FIELD NOTES

PROJECT: Rockwood 10

SUBJECT: West/ROW Planting and Associated Coordination

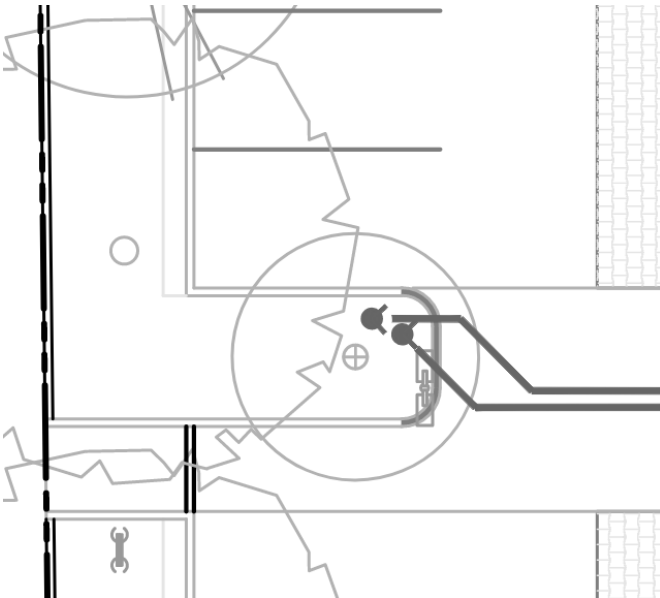
- a. Many materials are not yet available on site. In west parking perimeter Viburnum Tinus was reviewed. Material is undersized and may be an issue when reviewed by city. Spec calls for 24" height. Code requires 30" height within 12 months of planting.

Adjust spacing from fence to 30" typical (Teufel).

C6.0 Franchise Utility Plan

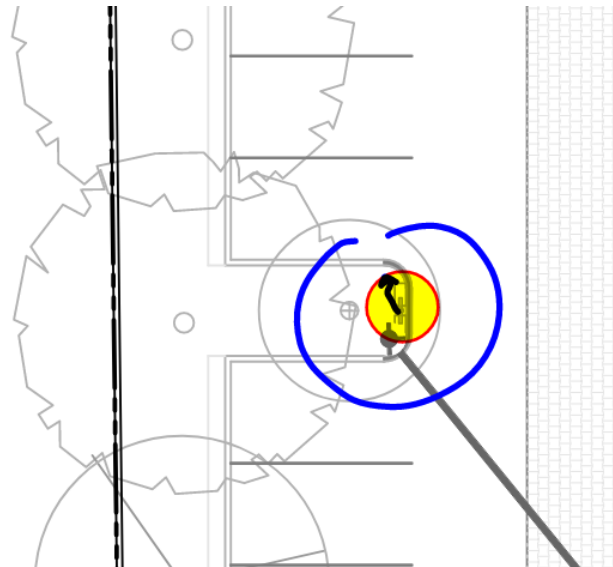
- a. Light Pole has been installed at center of island, however drawing calls for a south corner location. Please confirm if there is now a conflict with intended tree location (LMC).
